RE: Materials License 21-08317-01, Munson Medical Center

**From:** Forster, Sara [mailto:[Sara.Forster@nrc.gov](mailto:Sara.Forster@nrc.gov)]  
**Sent:** Monday, November 13, 2017 3:20 PM  
**To:** Aurand, Dennis <[daurand@mhc.net](mailto:daurand@mhc.net)>  
**Subject:** Additional Information Request re Munson Medical Center Amendment, Lic. 21-08317-01, CN600842

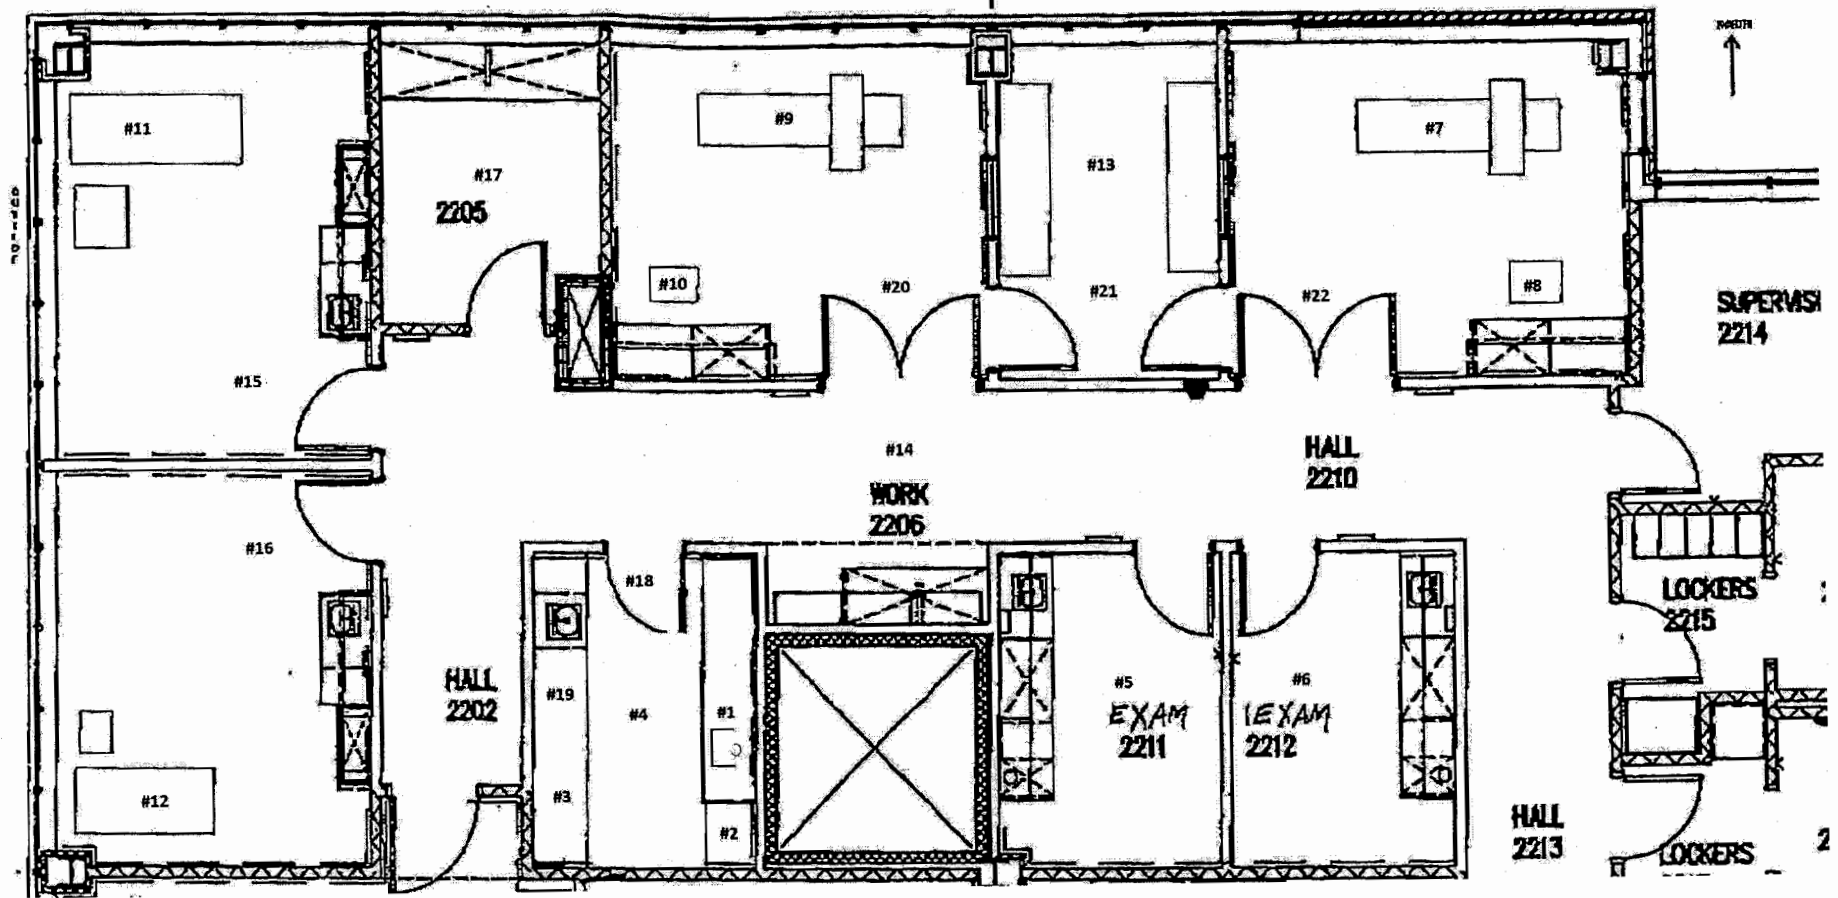
4. Regarding closeout surveys for the Suite to be removed from the license, please provide a copy of the final area survey results, including a diagram of the area surveyed with wipe locations keyed to spots noted on the diagram.

**Radiation Level Survey:** No area within the department demonstrated radiation levels in excess of the background reading of 0.02 mR/hr.

**Removable Contamination:** No area within the department demonstrated removable contamination excess of 50 dpm's.

<b>Area</b>	<b>Result in dpms</b>
#1 Dose Prep	0
#2 Waste Storage	4
#3 Package Receipt	2
#4 Hot Lab Floor	50
#5 Exam Room	0
#6 Exam Room	8
#7 Camera	0
#8 Acq/Processing Area	0
#9 Camera	0
#10 Acq/Processing Area	0
#11 Treadmill	40
#12 Treadmill	0
#13 Acq/Processing Area	10
#14 Hallway	0
#15 Treadmill Floor	0
#16 Treadmill Floor	0
#17 Exam Room	0
#18 Hot Lab Floor	0
#19 Hot Lab	2
#20 Imaging Room Floor	0
#21 Processing Room Floor	2
#22 Imaging Room Floor	0
